MFN 08-414 Supplement 1

**Subject: Response to Portion of NRC Request for Additional Information Letter No. 219 Related to the ESBWR Design Certification Application – Nuclear Boiler System - RAI Numbers 5.2-71 S01 and 5.4-59 S01**

**Response to Portion of NRC Request for  
Additional Information Letter No. 219  
Related to ESBWR Design Certification Application**

**RAI Numbers 5.2-71 S01 and 5.4-59 S01**

SIL357 Typical Steam Separator

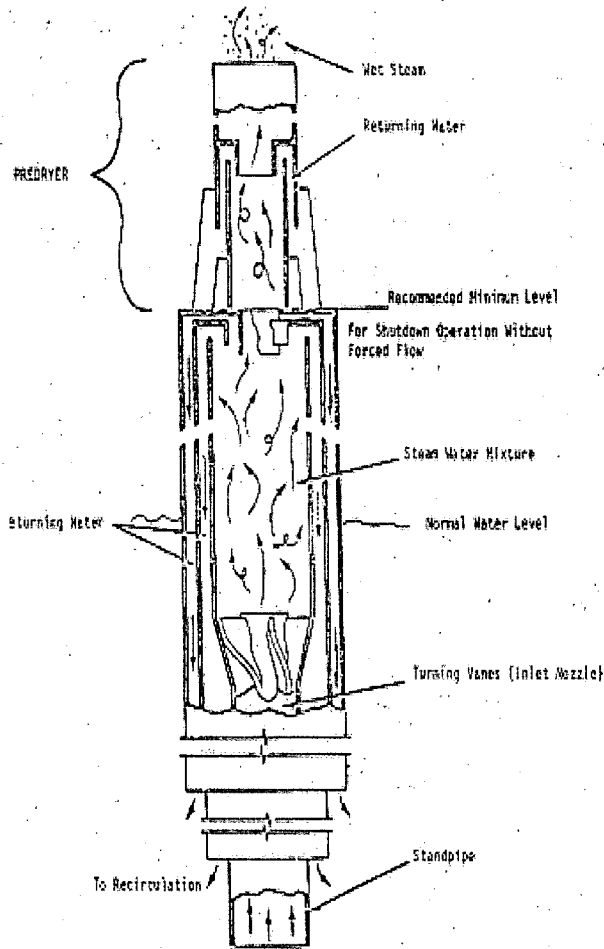
*(a) Please explain in the DCD and in TS the required minimum vessel level (elevation based on RPV bottom) to ensure that RWCU/SDC is capable of removing decay heat in all modes of operation. GEH SIL 357 recommends raising water level to a point above the bottom of the pre-dryers on the steam separators. GEH SIL 357 further states that the separator predryers are located slightly higher than the lowest fluid connection between the inside and the outside of the shroud. In contrast, the GEH RAI response and DCD Rev 5 states that water level should be maintained above the first stage water spill of the steam separators. Are these the same points? The staff understands that if water level is not high enough to promote natural circulation, thermal stratification of the vessel will occur with surface coolant temperatures increasing above 212 °F while RWCU/SDC temperature indication will remain below 212 °F. Inadvertent reactor*

The SIL 357 "bottom of the pre-dryers" water level is an administrative water level lower limit recommended to maintain shutdown cooling function in BWR series 2 through 6 designs. The SIL provides a figure depiction of a typical separator column with the upper portion identified as the pre-dryer. A similar figure schematically depicts the conceptual ESBWR steam separator column and shows that it is slightly different from the SIL-357 schematic figure.

The ESBWR separator column depiction shows three elevations or stages of condensate return. The RAI 5.4-59 initial response refers to the lowest of these three stages, whereas the ESBWR equivalent of the SIL-357 administrative limit

recommendation might be to maintain level at or above the second (middle) stage spillover elevation. The effect of this increased level on core circulation would be minimal since the ratio of vertical water column weight per unit area inside the core shroud compared to outside the core shroud would not be significantly changed, and would tend to favor increased circulation rate. Thus, SIL-357 represents operating experience that does apply to the ESBWR design in that an administrative lower water level limit should be established to effect a margin between the operating range for shutdown cooling mode and the analytical lower limit of the design. For the ESBWR, a determination of the recommended administrative vessel water level limits for operation of the RWCU/SDC system, during the shutdown cooling mode, are to be developed as part of human factors engineering (HFE) described in DCD Tier 2 Chapter 18.
